Application request for a Certificate of Appropriateness issuance on behalf of the property owner Mr. Robert Garner & Mrs. Jayne Owen.

Purpose: This application is in response to the previous denial application dated June 25, 2014 to the Houston Archaeological & Historical Commission for the Woodland Heights Historic District.

Location: 521 Euclid Street, Lot 1, Tracts 11 & 12A of Block 22 of the Woodland Heights Subdivision

# GARNER RESIDENCE

# A2

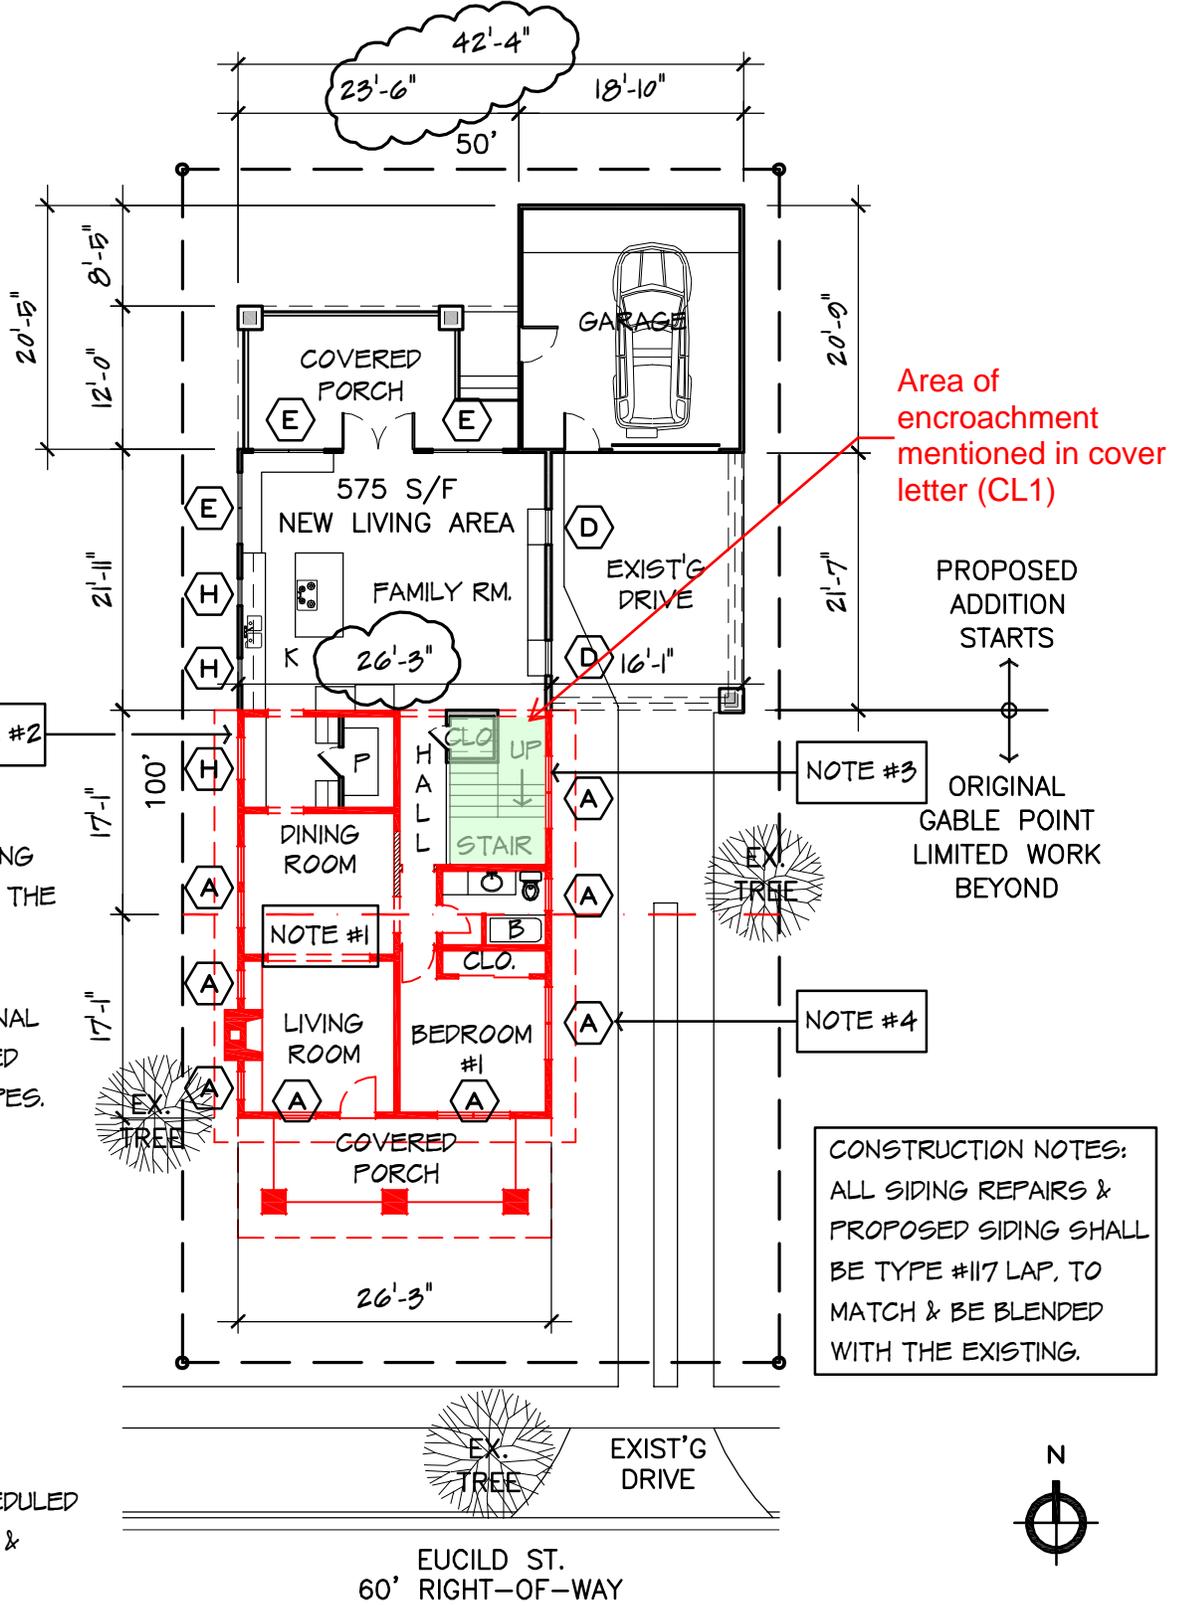
1. Addition will encroach 10' into the rear of the original house - The addition encroachment is exactly 13' X 8'-8", refer to drawing A4, Also the design was revised so that the use of the existing windows, previously noted to be removed, will remain as original. Please refer to drawing A3. Although the stairs remain in the same space this design flipped the direction of the stair and reduced the number of risers in front of these windows in question. It is the intent of this design to maintain the existing interior casework at these windows "as-is" and place the new stair landing no higher than 4" below the existing sill height.

Area of encroachment mentioned in cover letter (CL1)

#3 - EXIST'G ORIGINAL WINDOWS TO REMAIN. NEW STAIR LANDING TO NO GREATER THAN 4" BELOW EXIST'G SILL TO MAINTAIN WINDOW FUNCTION, TYP.

# A4

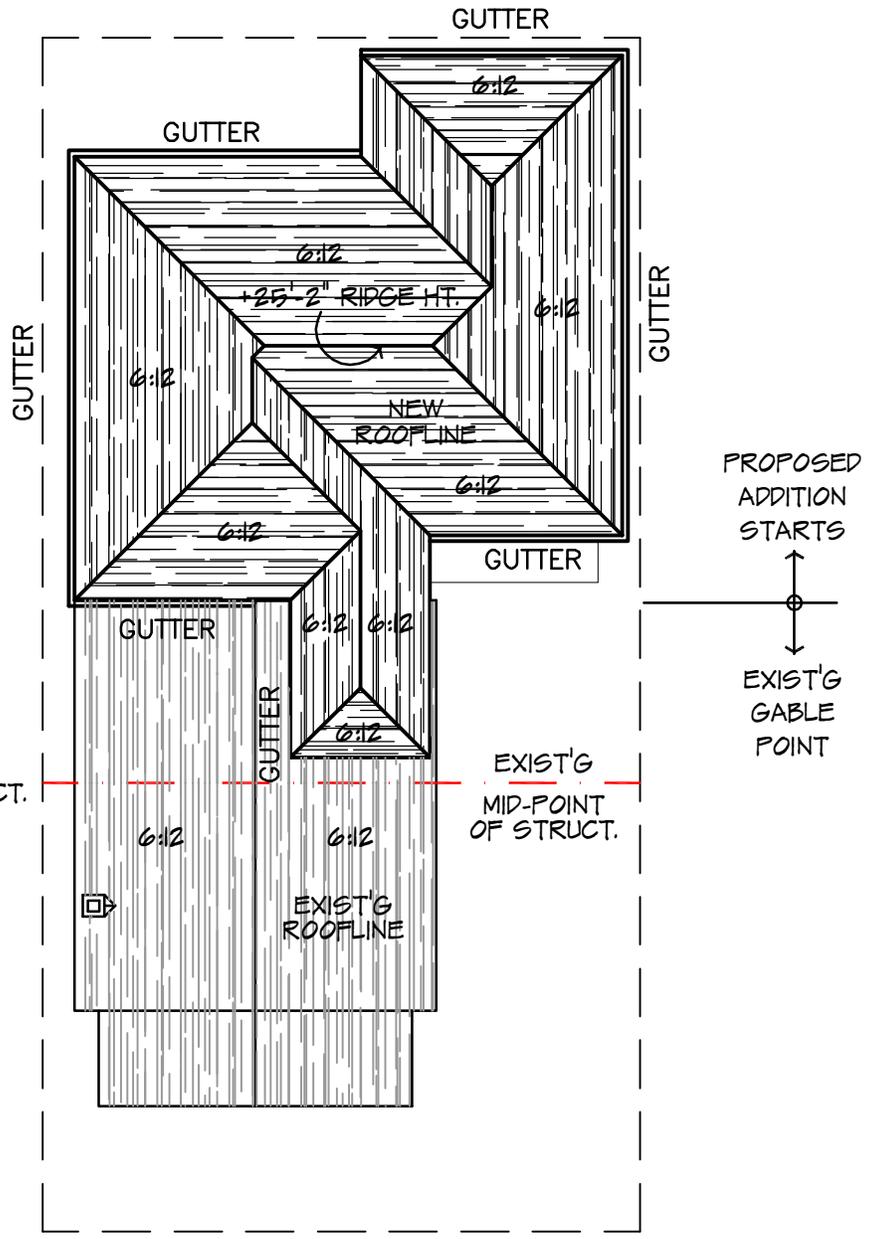
-the roof ridge height has been modified to accommodate an overall dimension of less than 27 feet, as recommended via email by HAHC staff. this was done by reducing the second floor plate height to 8 feet (in lieu of the previous design of 9') keeping the second level plate height no larger than the existing, which is 8 feet 6 inches above finished floor. combined with lowering the roof pitch, this allows the overall to be less than the request of 27 feet.

NOTE:  
 EXISTING ROOF PITCH IS  
 6:12 SLOPE. ALL NEW ROOF  
 SLOPES SHALL MATCH THE  
 EXISTING @ 6:12 W/ GUTTERS  
 WHERE SHOWN & CRICKETS  
 AS REQUIRED FOR WATER  
 DIVERSION AWAY FROM STRUCT.
